R66 SERVICE BULLETIN SB-16

SUBJECT: "LOT 20" F642-1 Shaft Corrosion

ROTORCRAFT AFFECTED: R66 Helicopters S/N 0143 thru 0172.

FIGURE 1

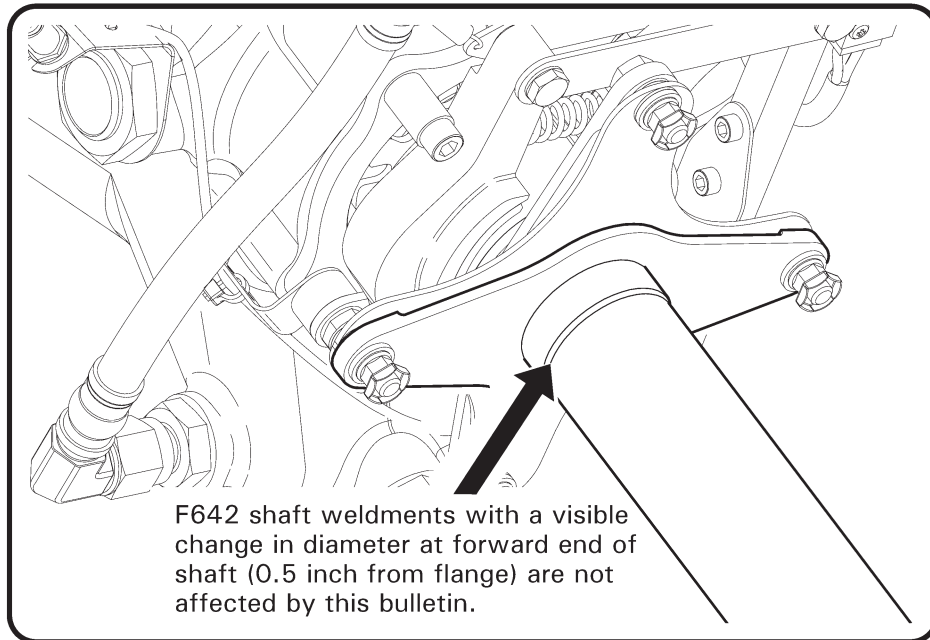
1. Refer to Figure 1. Visually inspect forward end of installed F642 shaft weldment for a visible change in diameter. Shafts with a change in diameter at location shown are not affected by this bulletin; no further action is required.
2. If installed shaft does not have a change in diameter at location shown, locate ink-marked lot number on F642-1 shaft (adjacent to ink-marked part number and revision letter). Ink-mark may be located on shaft or flanges (disassembly from flex plates may be required; refer to R66 Maintenance Manual [MM] § 63-10).
3. If shaft is marked "LOT 20", or if the lot number cannot be determined, remove shaft per MM § 63-10, order one R9535 kit from [RHC Customer Service](#), and install kit per MM § 63-10.
4. Make appropriate maintenance record entries. No change to helicopter weight and balance.
